Intersection ID: 17899	Main Street: STACY_BV	Cross Street: GARRIS_RD	Location:	NW
ADA ID: 61499A78ACA8	Ramp Type: Perp	Initial Pass/Fail: Fail	Overall Compliance: No	Severity Score: 1.25

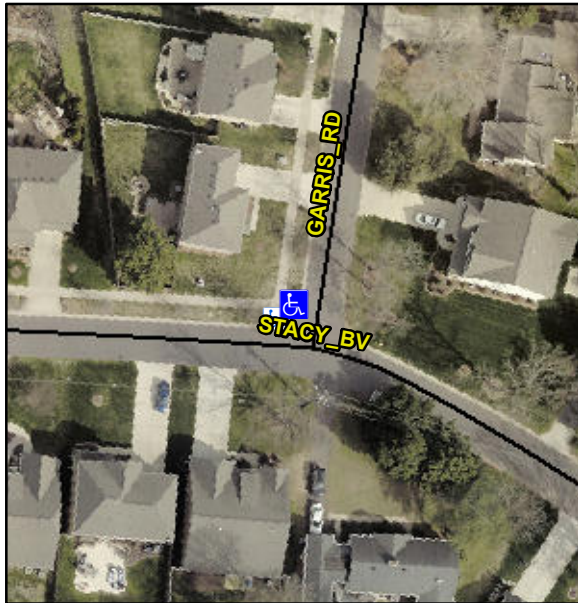
Not Found, R304.5.3

Possible Solutions:			Compliance	Description	Data	Compliance	Description	Data
Remove & Replace Entire Ramp.			N/A	Ramp Length (in)	94.0	Yes	Ramp Slope (%)	7.4
			Yes	Ramp Width (in)	48.0	No	Ramp XSlope (%)	3.6
			N/A	Flare Type LT	N/A	N/A	Flare Type RT	N/A
			N/A	Flare Slope LT (%)	N/A	N/A	Flare Slope RT (%)	N/A
			N/A	Flare Traversable LT?	N/A	N/A	Flare Traversable RT?	N/A
			N/A	Landing Length (in)	N/A	N/A	DWS Provided?	N/A
			N/A	Landing Width (in)	N/A	N/A	DWS Contrast?	N/A
			N/A	Landing Slope (%)	N/A	N/A	DWS Length (in)	N/A
			N/A	Landing X Slope (%)	N/A	N/A	DWS Full Width?	N/A
			N/A	Landing Curb? (Y/N)	N/A	N/A	DWS Offset (in)	N/A
			N/A	Shared Landing?	N/A			
			N/A	Gutter Ponding?	N/A	N/A	Gutter Slope (%)	N/A
Surveyor Notes: N/A			N/A	Gutter Lip Ht (in)	N/A	N/A	Gutter X Slope (%)	N/A
			N/A	Painted X Walk1?	No	N/A	Painted X Walk2?	N/A
				X Walk 1 Direction	To E		X Walk 2 Direction	N/A
			N/A	X Walk 1 Width (in)	N/A	N/A	X Walk 2 Width (in)	N/A

X Walk 1 Slope (%)	2.2		X Walk 2 Slope (%)	N/A
				X Walk 1 X Slope (%)	2.4		X Walk 2 X Slope (%)	N/A
			N/A	Ramp inside XWalk1?	N/A	N/A	Ramp inside XWalk2?	N/A
				Road Slope (%)	N/A	N/A	Clear Space?	N/A
				Road X Slope (%)	N/A	N/A	Clear Space to XWalk (in)	N/A
			N/A	Any Obstructions?	N/A	N/A	Storm Grate/Utility Hazard?	N/A
				Obstruction Type			Storm Grate/Utility Type	
					N/A			N/A
Total Cost:			\$	1850.00		Yes	Surface Condition? (G/P)	Good

Remove & Replace Entire Ramp.
